Rezoning Transportation Analysis

Petition Number: 2019-156

General Location Identifier: 08114708, 08114709

Revision Log:

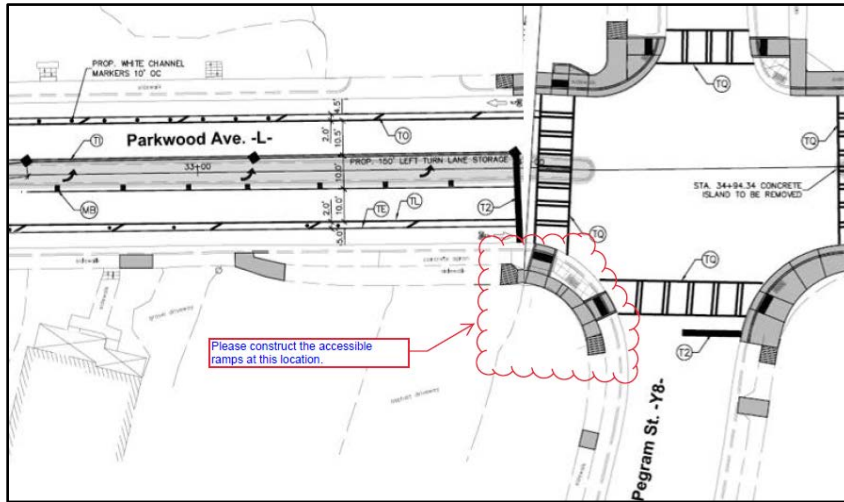
- ~~**Curblines**~~ The proposed zoning district has a setback measured from back of the existing or proposed future curblines.
 - ~~**Parkwood Avenue:**~~ The future location of curb and gutter is in its existing location.
 - ~~**Pegram Street:**~~ The future location of curb and gutter is in its existing location.

The site plan should show the curb and gutter labeled and dimensioned from the centerline for each road.
- ~~**Traffic Study**~~ A Traffic Impact Study is not necessary for the complete review of this petition.
- ~~The petitioner should revise the site plan and conditional note(s) to commit to construct two directional ramps at the intersection of Parkwood Avenue and Pegram Street, per the *Parkwood (N. Davidson – The Plaza) Improvements* construction plans. Please refer to these plans within the rezoning site plan and conditional note(s). The *Parkwood (N. Davidson – The Plaza)* plans are available upon request.~~

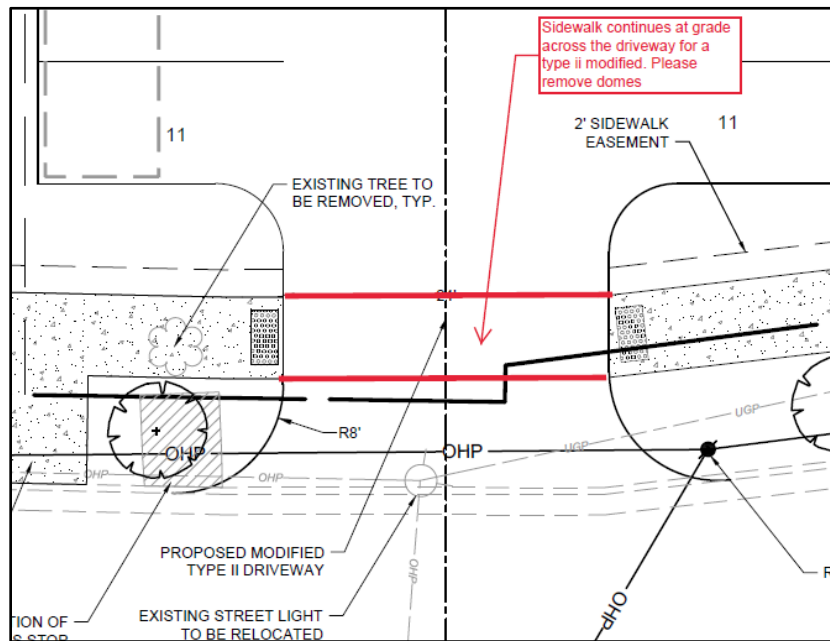
4. The petitioner should revise the site plan and conditional note(s) to remove the truncated domes and to continue the sidewalk at-grade across the driveway.

5. The petitioner should revise the site plan to add a note specifying dedication and fee simple conveyance of all rights of way to the City before the site's first building certificate of occupancy is issued. CDOT requests right of way set at 2 feet behind the back of sidewalk where feasible.

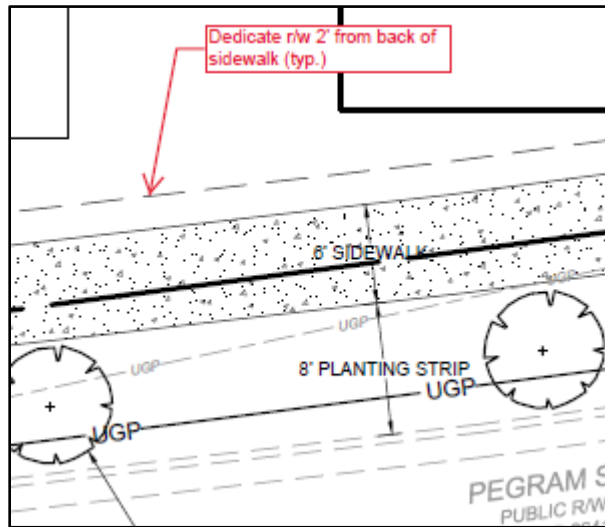
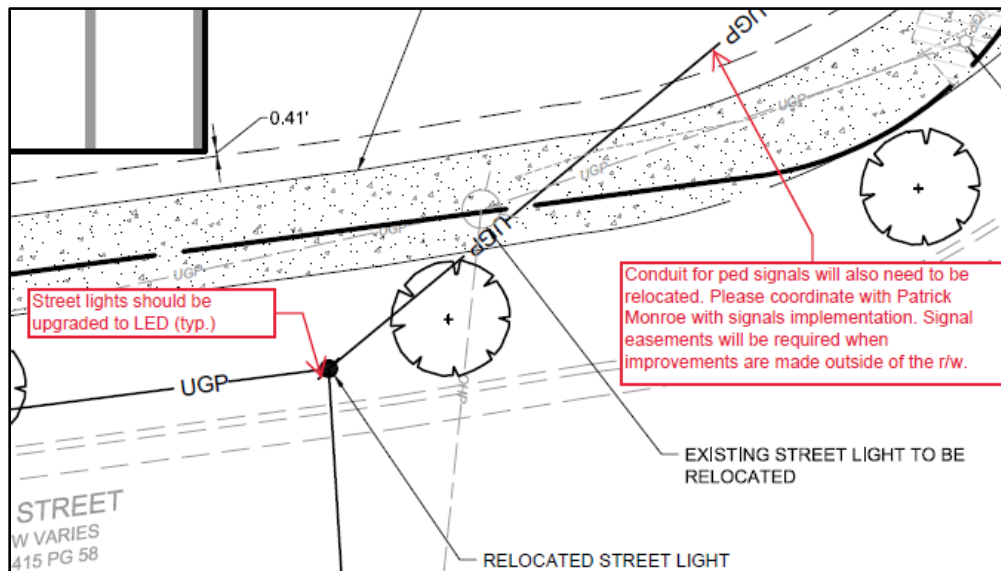
- The petitioner should revise the site plan and conditional note(s) to include utility easements where underground conduit is placed outside of the public r/w for the relocated street lights. The petitioner should commit to upgrading the street lighting along the site's right-of-way frontage to LED. Coordinate with Patrick Monroe (Patrick.Monroe@ci.charlotte.nc.us at 704-336-3937).

- The petitioner should revise the site plan and conditional note(s) to clearly define the on-site ordinance required bicycle parking.
